The attached set of plans and documents represent the PDD(GDP) project drawings and related zoning documents for Midtown Commons, a mixed-use neighborhood located in Madison, Wisconsin at 8102 Mid Town Road, more particularly described as:-

### PRELIMINARY PLAT OF MID TOWN COMMONS

Re: Letter of Intent  
Midtown Commons  
8102 Mid Town Road  
General Development Plan

**SUBJECT: 8102 Mid Town Road**

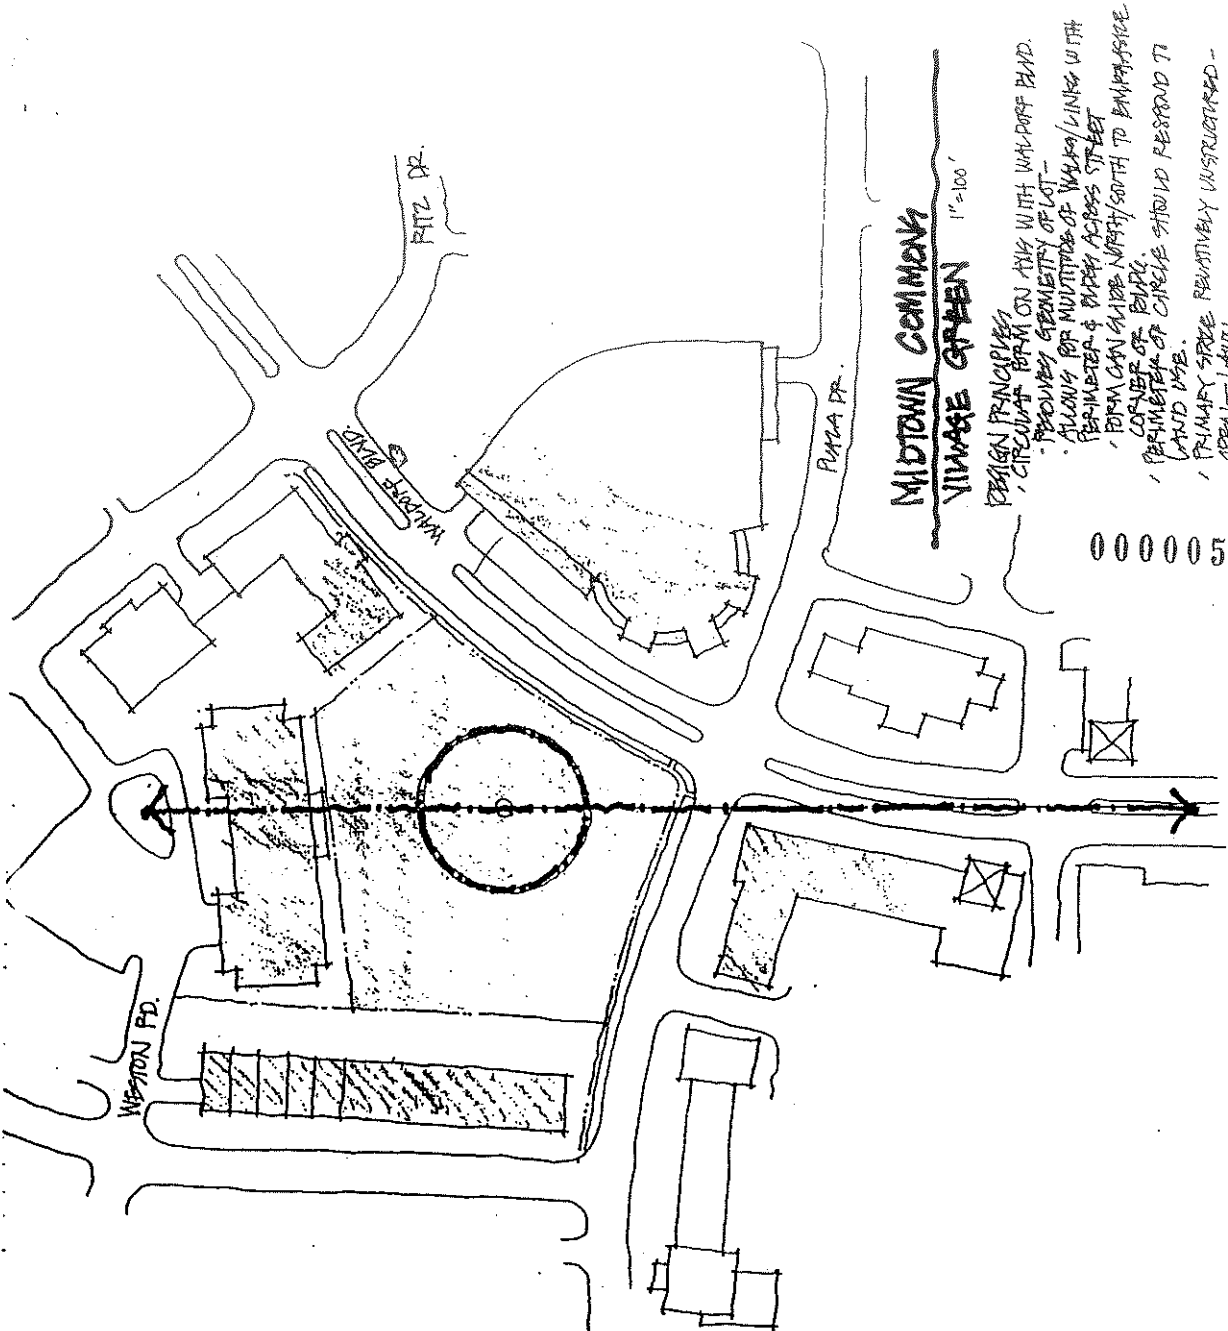
1. The applicant shall execute and return the attached declaration of conditions and covenants for streetlights prior to sign off.
2. Utility easements shall be provided as follows:

Between Lots	Between Lots	Between Lots
3-4	53-54	92-OL 10
7-8	57-OL 7	93-94
15-OL 5	64-OL 7	
16-17	73-74	
18-OL 5	76-OL 8	
23-24	77-78	
24-25	79-80	
27-28	82-83	
31-32	85-86	
35-OL 6	86-87	
49-50	91-92

3. The plat shall note the following note, "One Access Drive shall be granted along the northerly right-of-way line of Mid Town Road." (Amended by Plan Commission on 8-28.)

4. The applicant shall note on the face of the plat as follows: A Note: Upon review and approval of each conditional use proposal for multi-family development on the R4 zoned lots, provisions for off-street parking are expected to exceed the minimum requirements of the Zoning Ordinance.

6. ~~Outlot 9~~<sup>\*(Revised to Outlot 6)</sup> of the plat shall be revised to 15-foot wide and located with respect to the existing ped-bike easements of the adjoining already adopted Valley Ridge plat. The final aspects of the easement including installation, grades, maintenance and liability shall be reviewed and approved by the Traffic Engineer.

7. ~~Outlot 10~~<sup>\*(Revised to Outlot 7)</sup> of the plat shall be revised to 15-foot wide and located with respect to the existing ped-bike easement of the adjoining already adopted plat. The final aspects of the easement including installation, grades, maintenance and liability shall be reviewed and approved by the Traffic Engineer.

8. ~~Outlot 3~~<sup>\*(Revised to Outlot 9)</sup> may need to be increased in width depending on the design planned with the Parks Division.
9. The rights-of-way of Starr Grass Drive, Mansion Hill Avenue and Waldorf Boulevard shall be 70-feet. (Amended by Plan Commission on 8-28.)

10. The intersection of Starr Grass Drive and Mansion Hill Avenue shall be designed to include a roundabout design to help provide for the east-west collector function planned for this part of the neighborhood and neighborhood development plan. The ROW shall reflect this and be reviewed and approved by the Traffic Engineer. The islands shall be landscaped and maintained by the developer, unless otherwise determined by the Traffic Engineer.

11. In areas where there is dense residential or commercial development the streets rights-of-way may need to be increased to 60-feet. The streets that may need to be increased to 60-foot ROW include Plaza Drive, parts of Starr Grass Drive, and parts of Ritz Road. (Amended by Plan Commission on 8-28.)

17. The streets named Plaza Drive, Weston Drive, and Hilton Road shall be changed because they conflict with existing streets having the same or similar names. The street named Midtown Road shall be changed to Mid Town Road. All street names are subject to approval of the City Engineering Division.

18. The plat shall be revised to show a 40-foot setback line on all lots adjacent to Mid Town Road.
19. The developer shall construct Madison standard street improvements for all streets within the plat.

31. The plat shall be revised to show at 100-foot wide greenway dedication to tie in the major drainageway to the north of this plat.
